ISSUE: Permit to Demolish/Capsulate (partial) and Certificate of Appropriateness for addition

APPLICANT: Alex and Sydney McCormack

LOCATION: Old and Historic Alexandria District
821 South Lee Street

BAR#2025-00499 & BAR#2025-00500 OHAD
821 South Lee Street

Figure 1: 821 South Lee rear elevation as seen from South Fairfax

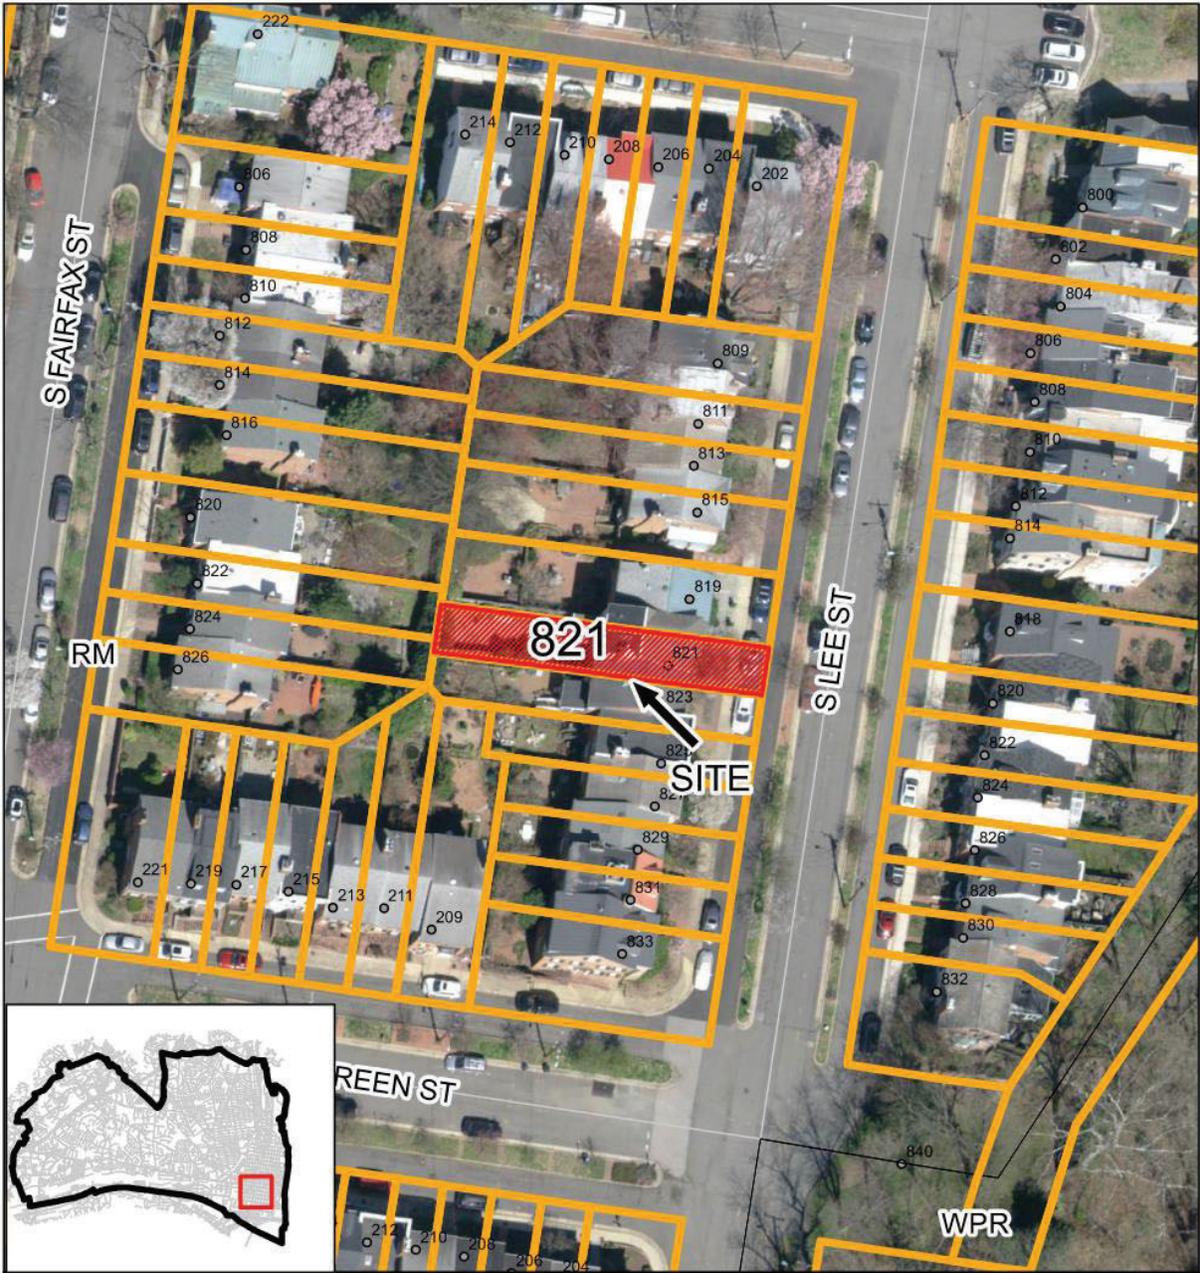
There is no alley behind the subject property. The rear elevation is not visible from Green Street, and the third story only is minimally visible from South Fairfax Street. See Figure 1. As the proposed addition will be two stories, it will not be visible from any public right of way.
